Project: Our Lady of Fatima Catholic School
Site Work
Chatham, Ontario
SCCDSB 619-CP1706

Addendum: 1

ME No. 01

Architect:	ROA studio inc.	Attention:	Joseph Ouellette
Project:	Our Lady Fatima Catholic School Site Work 545 Baldoon Road, Chatham, On	Project No.:	17-012
Date:	May 4, 2017	Issued By:	Mohammed Jilani, P.Eng.

Parapet Fixture Mounting Detail

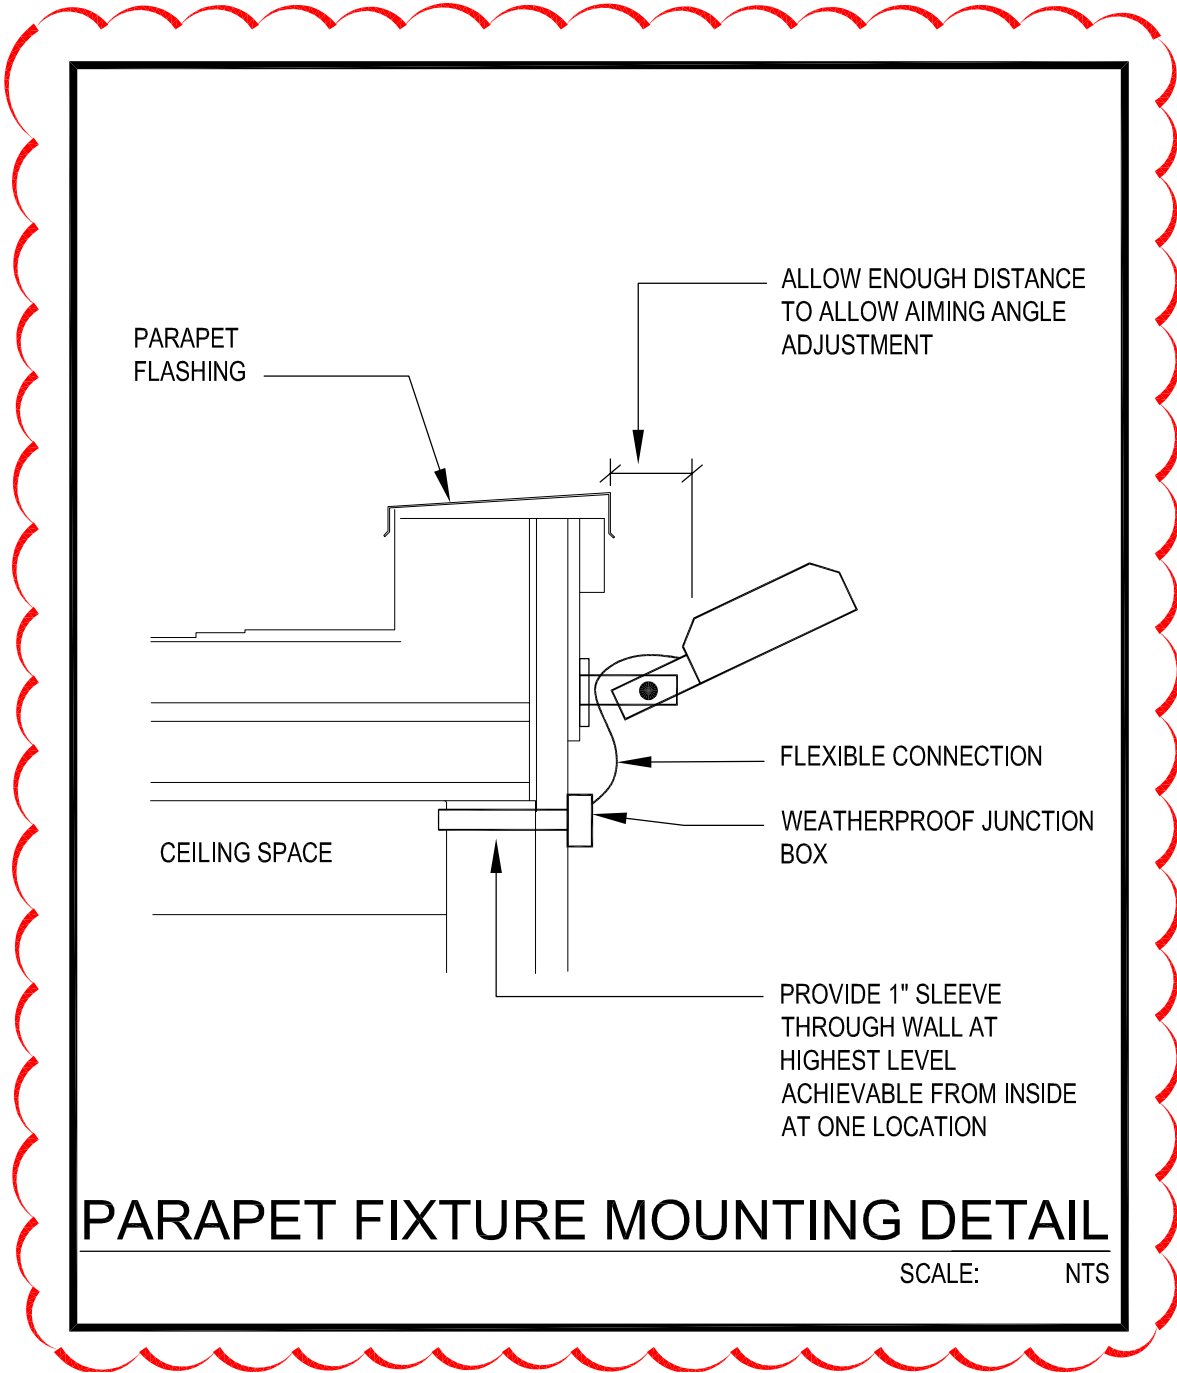
Document	Description
RFI May 1, 2017	<p><u>Request For Information:</u></p> <ol style="list-style-type: none"> 1. Can you please supply a detail for steel angle frame support for Fixture Types A. Who supplies and install's the support bracket? 2. For fixture types B mounted at 12' is it possible to run feed through school in $\frac{1}{2}$" EMT conduit and pop out with BX cable at locations shown rather than run rigid conduit along parapet on roof and mount junction boxes. You would then have to have teck cable hanging over the ledge. Also many LED wall packs do not have a provision for top entry. 3. Can the same be done for fixture type A? If not can we run through the school with EMT conduit to the exterior wall and then pop through the roof and install aluminum conduit along parapet from there.
Mechanical Electrical Drawings ME-101 and ME-102	<ol style="list-style-type: none"> 1. RFI Responses: <ol style="list-style-type: none"> a. Re question 1, See detail of fixture type 'A' installation as per attached sketch ME 102.1. The Electrical Contractor supplies and installs all supporting brackets for Trunion mounting on the wall such that the installation will allow enough clearance for aiming from -30° to +60° off horizon. b. Re question 2, 3/4" minimum, see response to question 3.

<p>c. Re question 3, route EMT through the school to exterior wall and then pop through the wall and install aluminum conduit along exterior (just below parapet coping) to each fixture.</p>
<p>Mechanical Electrical Drawings ME- 101 and ME-102</p>	<p>1. NEW ITEM: Disconnect and remove existing wall mounted fixtures on the east and west facades (total of 5) and turn them over to owner. Remove wiring back to source and patch and repair holes left behind after removal.</p>
